Bid Addendum #02

Addendum #: 02

project: Helena Distribution Store

project #: 224098

G-002

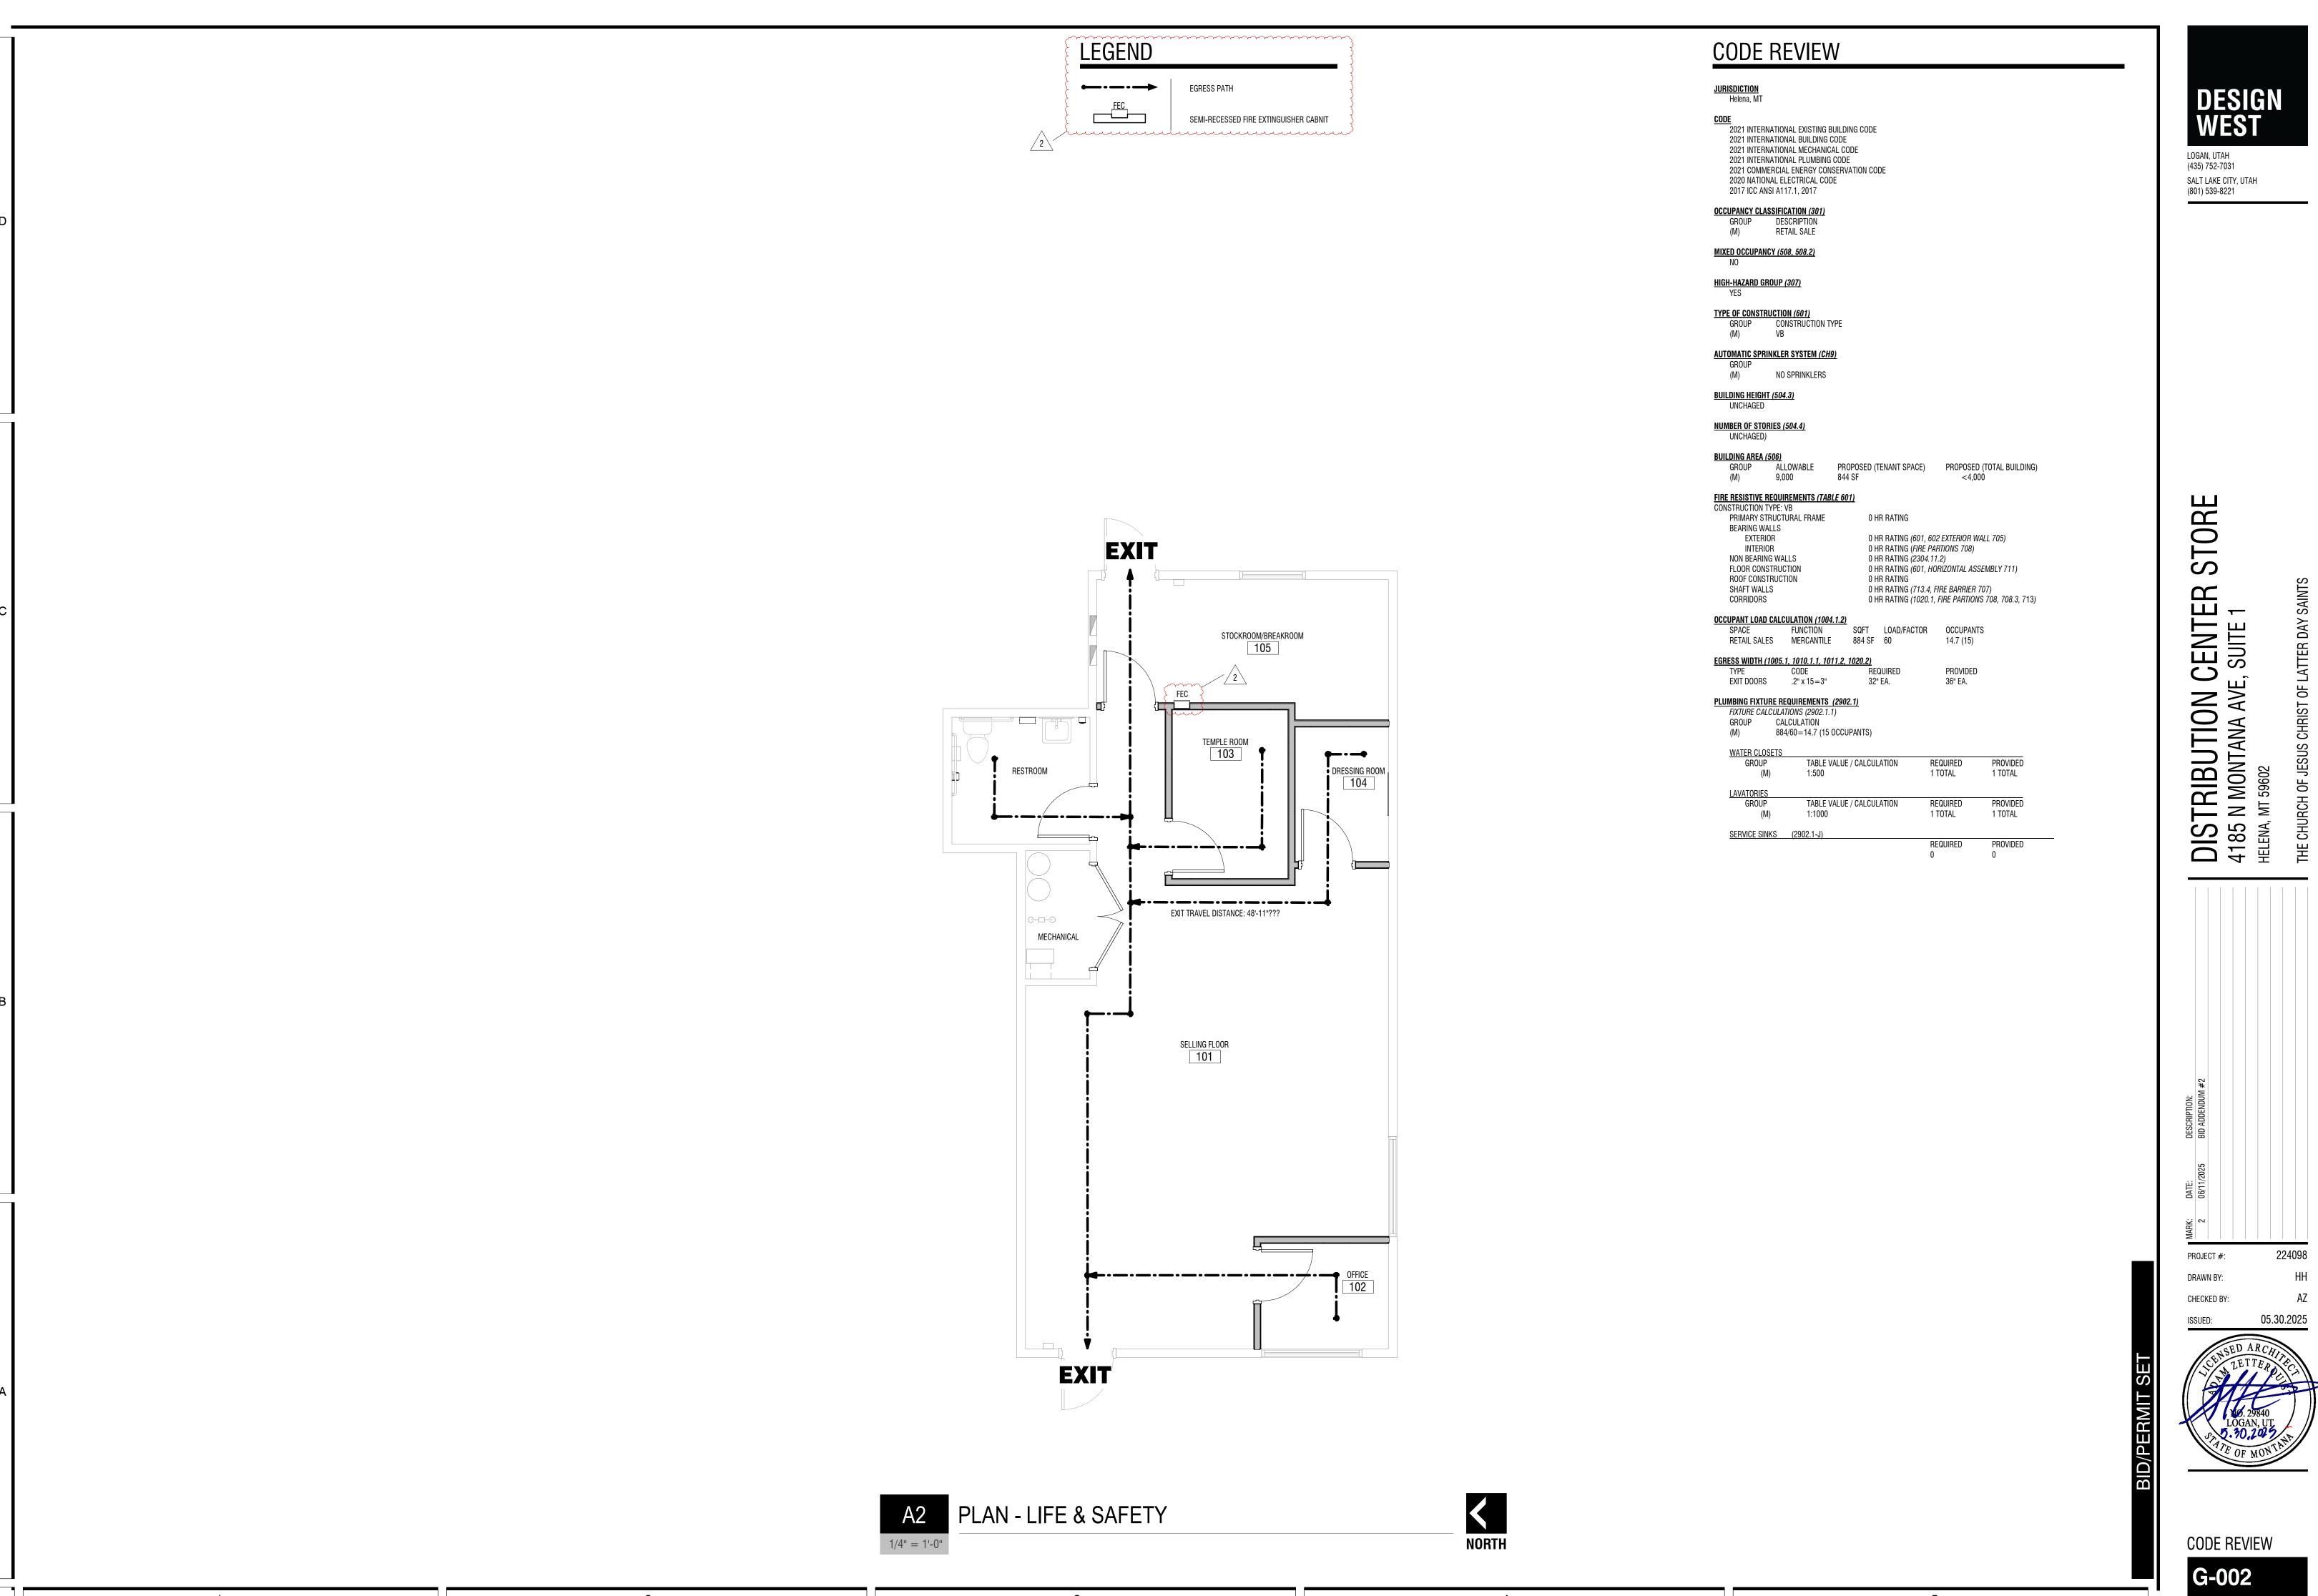
- Fire Extinguisher in Semi Recessed Cabinet added in Stock Room/Breakroom. Legend on G-002 updated.
- Dispensers in restroom are to be removed and discarded. Contractor to install new vendor supplied dispensers. Dispenser mounted height added on A-501.
- Gypsum Board wall and ceiling finishes added to Paint Schedule on A-601.

- Sheet G-002 references Sheet A531 for wall types but is not included in our plan set. Is there a sheet A531 that we are missing? Or is the detail of the wall type on sheet A-501 to be used?

- Sheet G-002 Legend calls for new walls to extend to the deck. Please provide the height to the deck to plan on for these walls.

- Please clarify if thermal batt's or sound insulation is desired in all new walls. G-002 legend isn't clear which walls receive which.

RESPONSE: WALL TYPES ARE ON A-501

RESPONSE: THE EXISTING GYP BOARD CEILING IS ATTACHED TO THE BOTTOM OF THE ROOF TRUSSES. NEW WALLS ARE TO EXTEND TO BOTTOM OF EXISTING CEILING.

RESPONSE: NONE OF THE NEW WALLS ARE TO RECEIVE INSULATION.

A-101

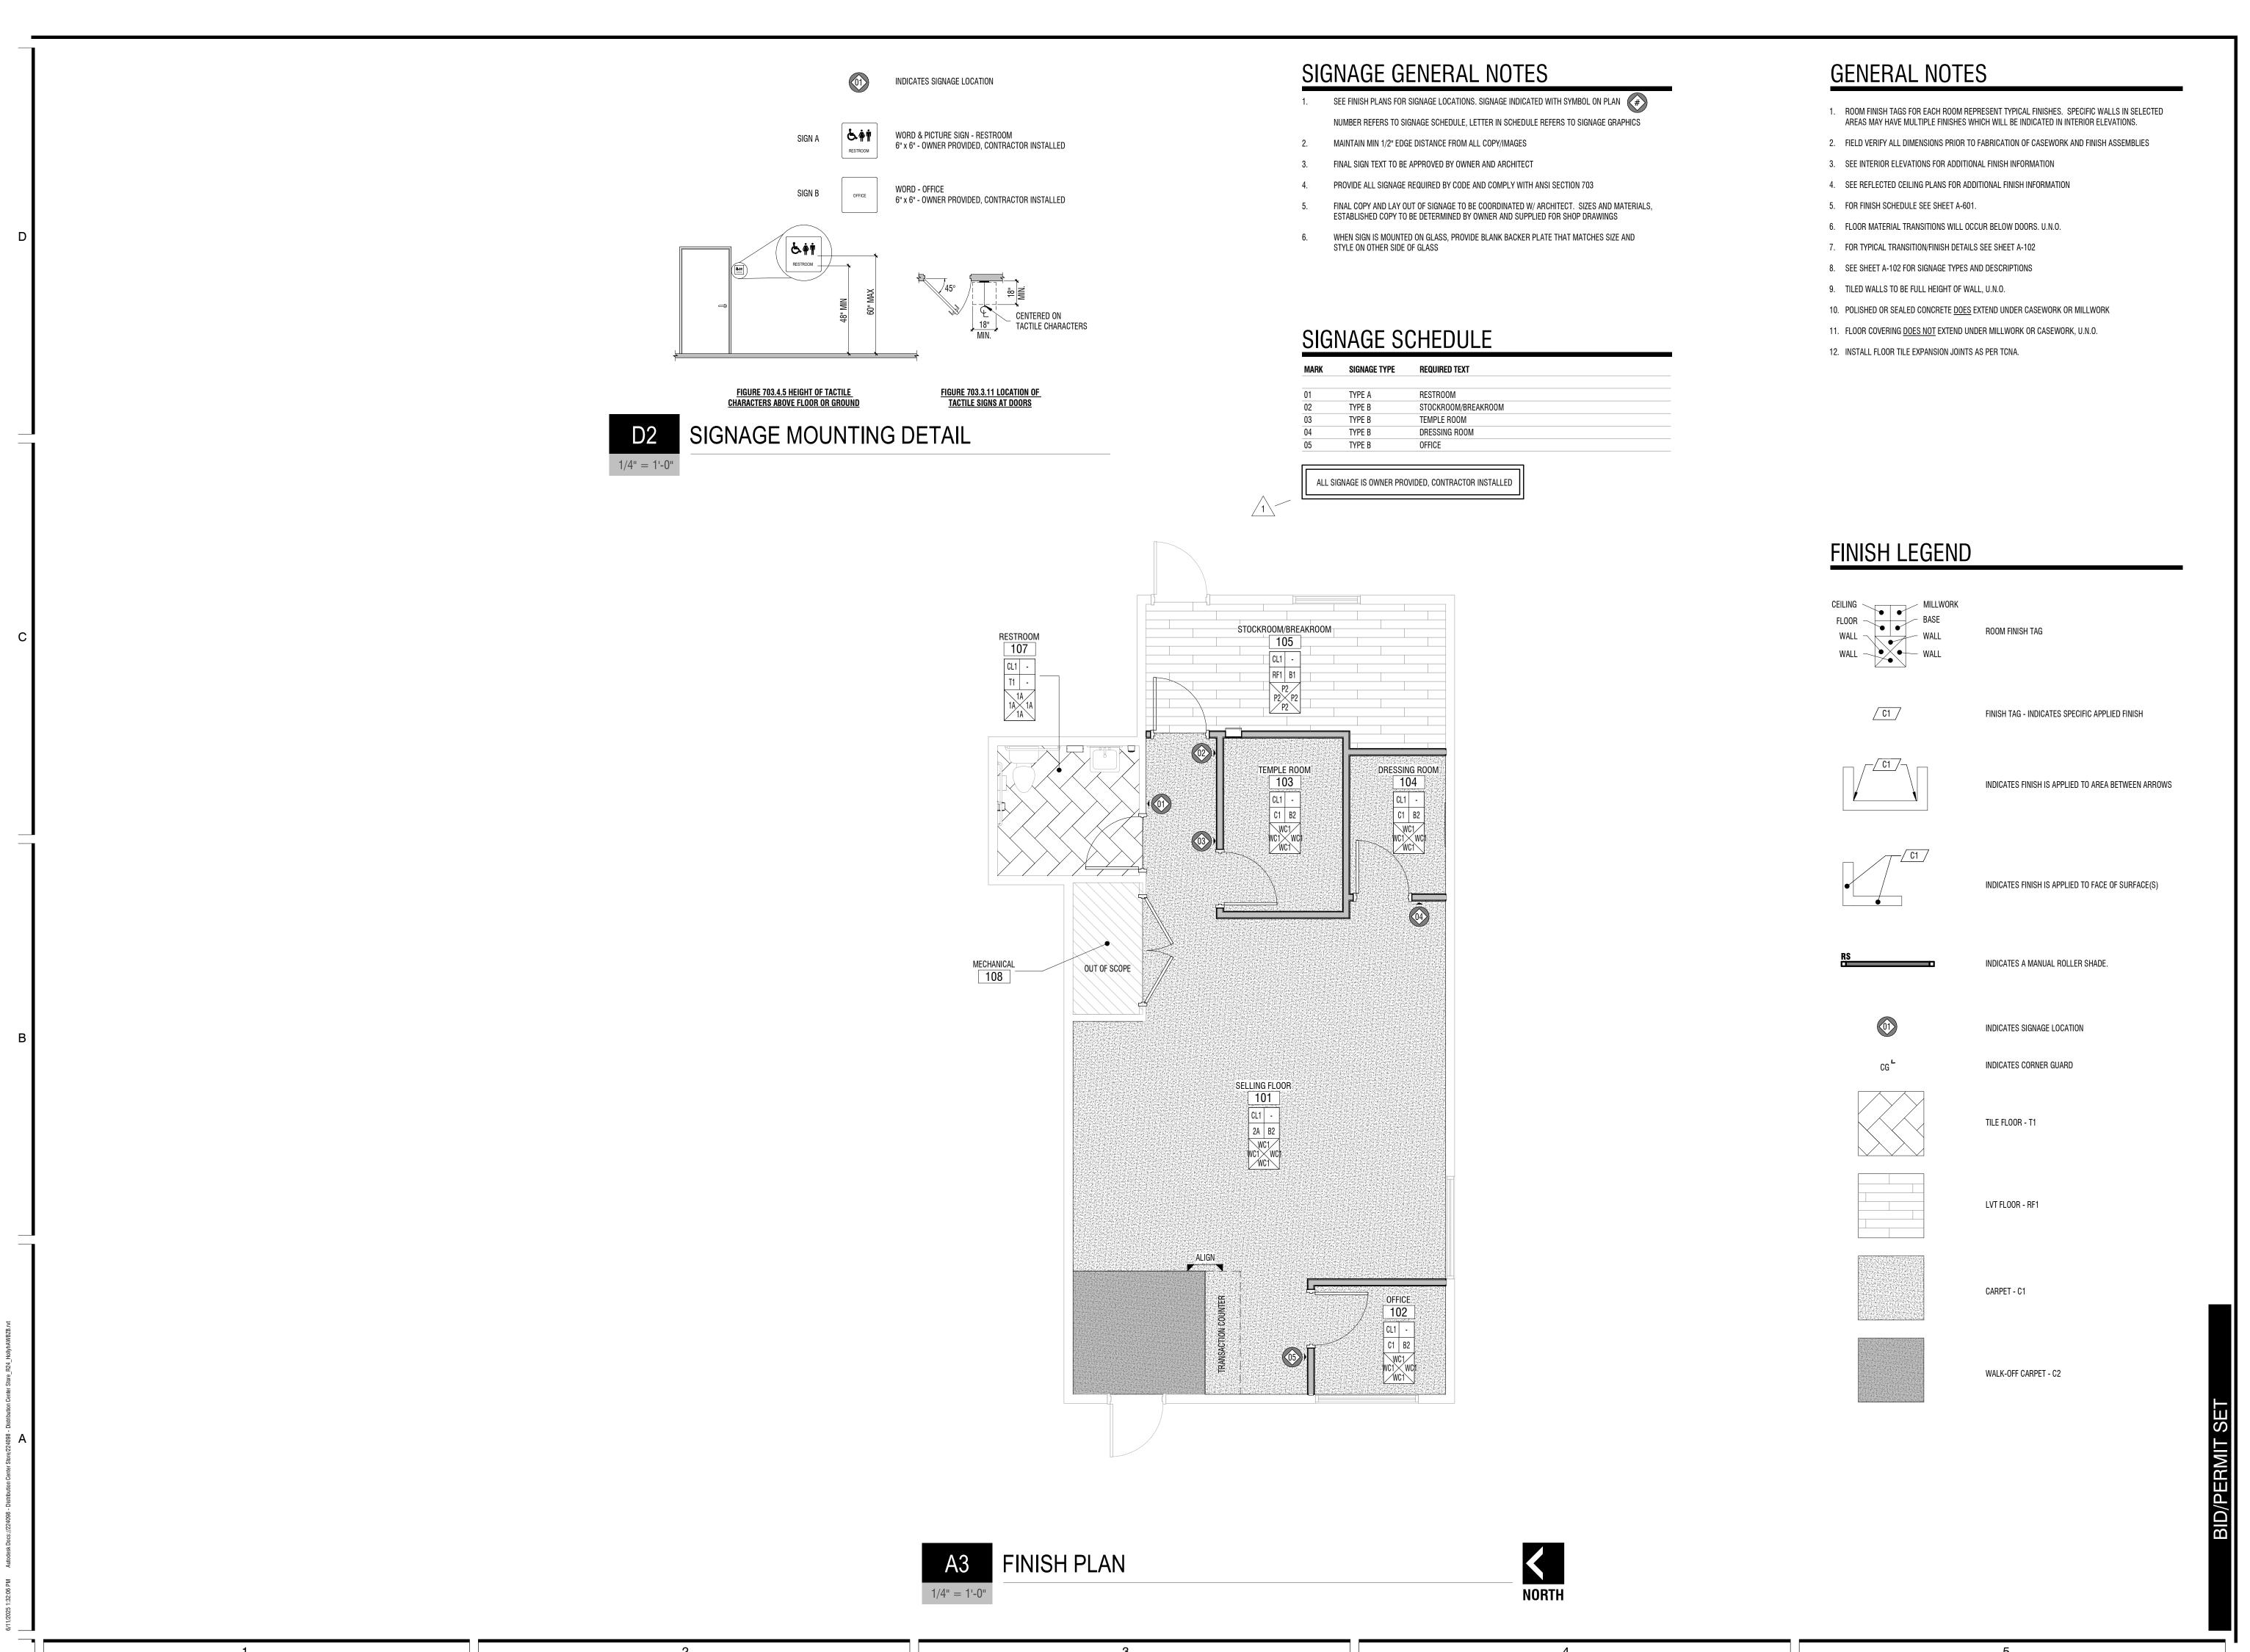
- Plans don't call for fire extinguisher location, assuming 1 new with cabinet per egress distances less than 75' - is that a correct assumption?

RESPONSE: ONE FIRE EXTINGUISHER IN A SEMI-RECESSED CABINET HAS BEEN ADDED IN THE STOCKROOM/BREAKROOM
